B.7.2 Transport Memo (February 2023)

22 February 2023

SCENIC RIM AGRICULTURAL INDUSTRIAL PRECINCT (SRAIP) TRANSPORT MEMO

Figure 2 New Cross Section - Road 1 (30.3m)

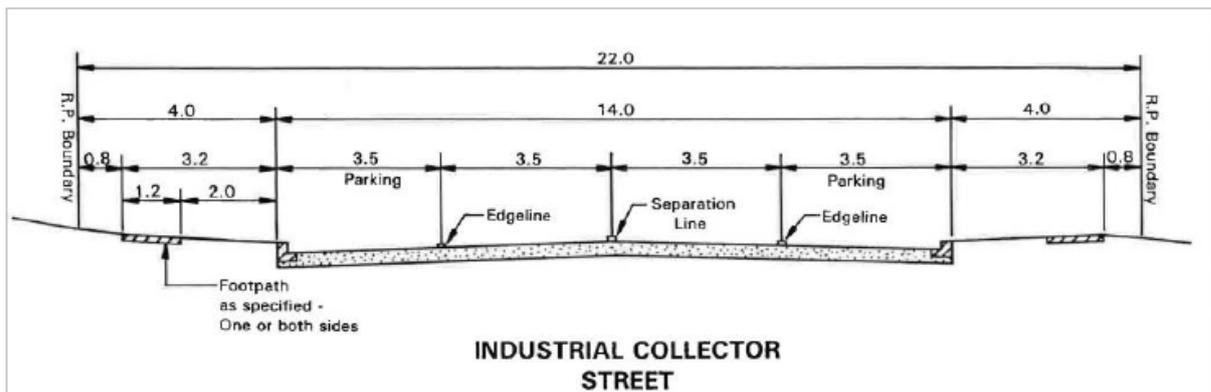
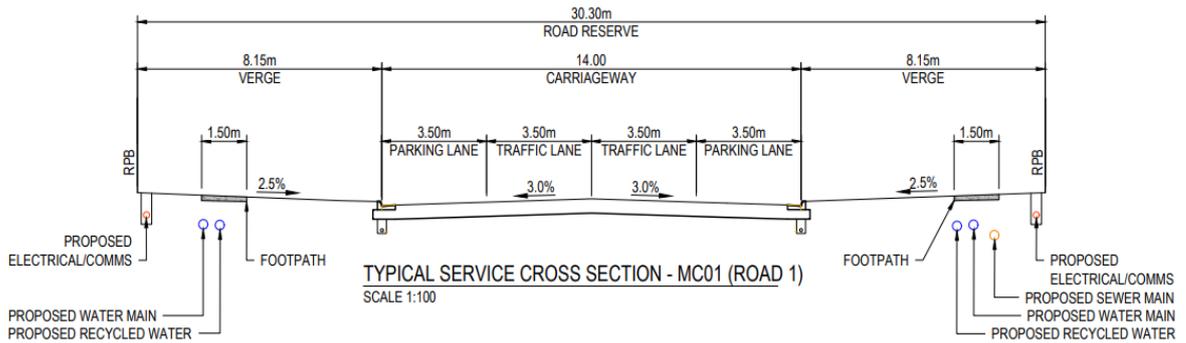
The proposed cross section for Road 1 (Cunningham Highway to Wagner quarry) is shown above on Figure 2. The width of the road reserve has been increased from 22.0m to 30.3m. The carriageway width and number of traffic lanes remain the same as the approved cross section. The increase in width is attributed to the verge which will be a much more generous width than that of the original at 8.15m compared to 4.0m as indicated within the Queensland Street standards. The minor adjustments will have no impact on heavy vehicle traffic or movements as there have been minimal changes made.

Internal access road cross sections have been updated to widen the road reserve from 22.0m (originally assessed) to 30.3m and 40.0m for Road 1 and Road 2, respectively. The widths of travel lanes and parking lanes on all road carriageways are consistent with the approved cross section and therefore, the proposed widened design is considered to be suitable for access to lots.

Figure 3 New Cross Section – Road 2 (40.0m)

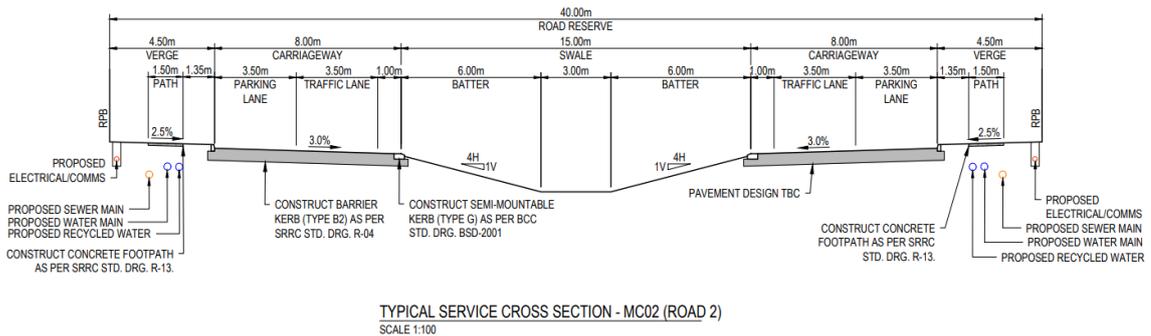
Figure 3 as shown above indicates a proposed road reserve of 40.0m for Road 2 (internal access from Road 1). This cross section shows the carriageway being median divided by a 15.0m wide swale. Each direction of travel includes 4.5m wide verge and 8.0m wide carriageway with 3.5m wide parking lane and 3.5m wide travel lane, adjacent to a 1.0m wide shoulder. This arrangement will be suitable for heavy vehicle access as the carriageway is generally consistent with the approved cross section. The provision of a divided carriageway will not prohibit access to properties, allowing for left in left out access.
